# 1953 - 1954 Corvette: Service News: Powerglide Clutch Interference

**Subject:** Powerglide Clutch

**Model and Year:** 1953 - 1954 Corvette

**Source:** Chevrolet Service News

*Fig. 2—Powerglide Valve Body Re-worked.*

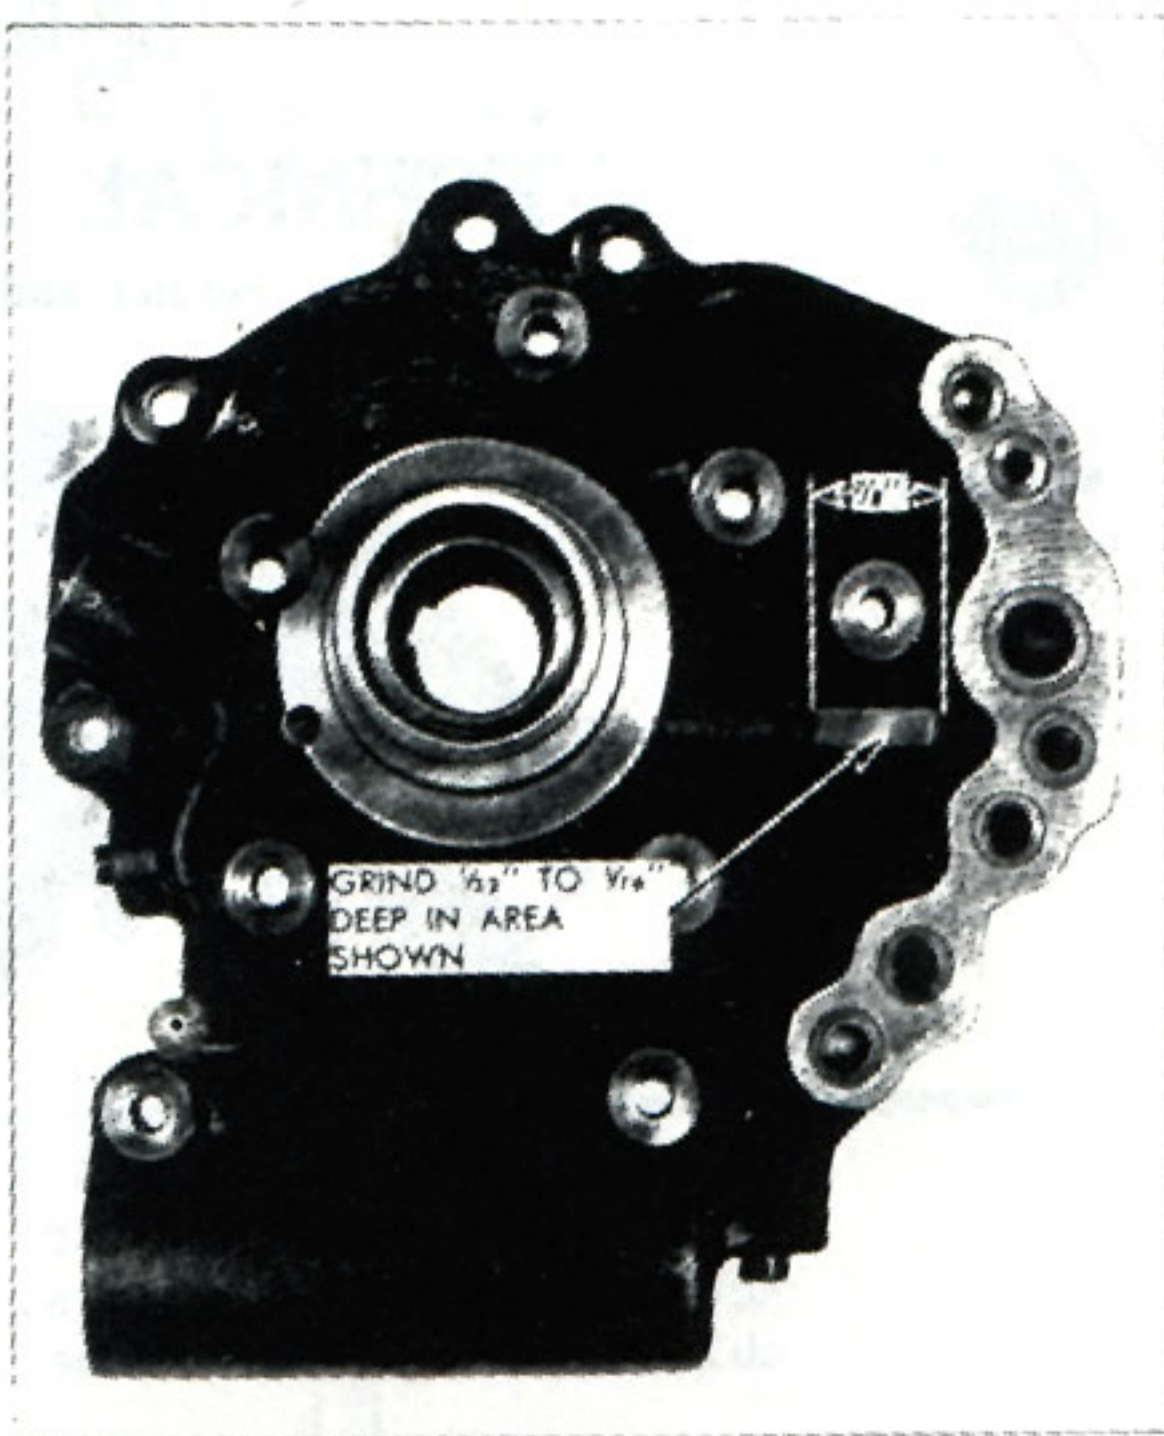
Due to limit stack conditions, a point of interference is possible when using a service replacement clutch drum or clutch assembly in 1953-54 Powerglide transmissions. The difficulty is caused by a ledge incorporated on the front face of a service replacement clutch drum, which can contact an embossed area on the valve body casting.

Where clutch drum-valve body interference is noted when installing one of the above assemblies the valve body must be reworked to obtain drum operating clearance, as shown in Figure 2.
